Hard to re-open door reduce the time between door openings (FzFF240 and FzFF280)

Freezer
FzFF240/280

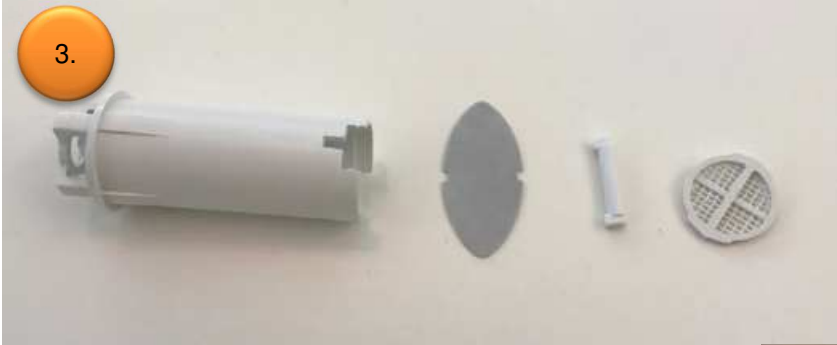
2. Drill a hole with a 27mm drill to the left side of the inner liner.

Parameters:

50mm from the bottom and 20mm from the side.

If the hole does not fully penetrate – place the centre tip in the small hole created on the back and complete from the back.

Or if you clean the hole saw, you can “reboot” and finish it from the front side if the drill is long enough.

3. Assemble the valve according to the instructions supplied with the valve.
Place the valve in the hole.
Put back the drawer.
